# Access Compliance Report

## Public Rights-of-Way

Intersection ID: 31894	Main Street: GREEN_MOUNTAIN_RD	Cross Street: MOUNTAIN_SPRINGS_DR	Location:	N
ADA ID: C99A2C15662A	Ramp Type: BlendTrans1	Initial Pass/Fail: Fail	Overall Compliance: No	Severity Score: 10
Codes/Mitigation Info/Possible Solution		Field Measurements/Component Compliance

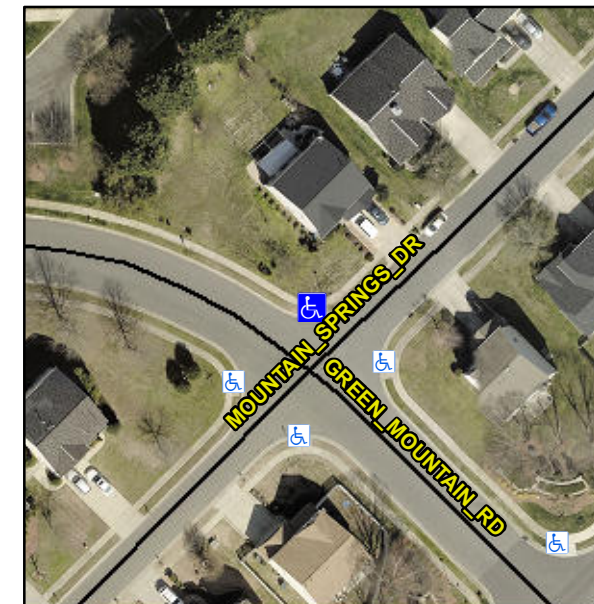
**Remove & Replace Curb Ramp With Two New Directional Ramps or Equivalent.**

**R304.5.1, R304.5.3**

Compliance	Description	Data	Compliance	Description	Data
N/A	Ramp Length (in)	47.5	Yes	BlendTrans Slope (%)	4.5
No	Ramp Width (in)	40.5	No	BlendTrans XSlope (%)	3.4
N/A	Flare Type LT	N/A	N/A	Flare Type RT	N/A
N/A	Flare Slope LT (%)	N/A	N/A	Flare Slope RT (%)	N/A
N/A	Flare Traversable LT?	N/A	N/A	Flare Traversable RT?	N/A
N/A	Landing Length (in)	N/A	N/A	DWS Provided?	N/A
N/A	Landing Width (in)	N/A	N/A	DWS Contrast?	N/A
N/A	Landing Slope (%)	N/A	N/A	DWS Length (in)	N/A
N/A	Landing X Slope (%)	N/A	N/A	DWS Full Width?	N/A
N/A	Landing Curb? (Y/N)	N/A	N/A	DWS Offset (in)	N/A
N/A	Shared Landing?	N/A			
N/A	Gutter Ponding?	N/A	N/A	Gutter Slope (%)	N/A
N/A	Gutter Lip Ht (in)	N/A	N/A	Gutter X Slope (%)	N/A
N/A	Painted X Walk1?	No	N/A	Painted X Walk2?	No
	X Walk 1 Direction	To SW		X Walk 2 Direction	To SE
	X Walk 1 Width (in)	N/A		X Walk 2 Width (in)	N/A
	X Walk 1 Slope (%)	0.6		X Walk 2 Slope (%)	3.7
	X Walk 1 X Slope (%)	1.9		X Walk 2 X Slope (%)	0.9
